FIRE SAFETY INSPECTION REPORT

MAWNA FASHION LTD.

ACCORD ID: 11954

February 14, 2015

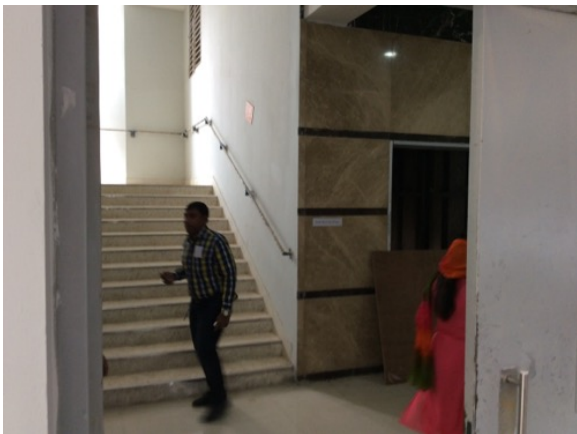
F-2	Fire Rated Construction	Rooms used for combustible storage on the ground floor are not separated by fire-rated construction.	<p>Provide dedicated storage rooms separated by minimum 1-hr fire-rated construction.</p> <p>Where separate storage rooms are not feasible, provide defined storage areas and limit the storage arrangement as follows:</p> <ul style="list-style-type: none">- Maximum height of 2.45m (8ft.) and maximum area of 23m² (250 ft²)- If sprinkler protected: maximum height of 3.66m (12ft.) and maximum area of 93m² (305ft²) <p>Separate areas of unenclosed combustible storage by a minimum clear distance of 3m (10ft.).</p>	Within 3 months
-----	-------------------------	--	--	-----------------
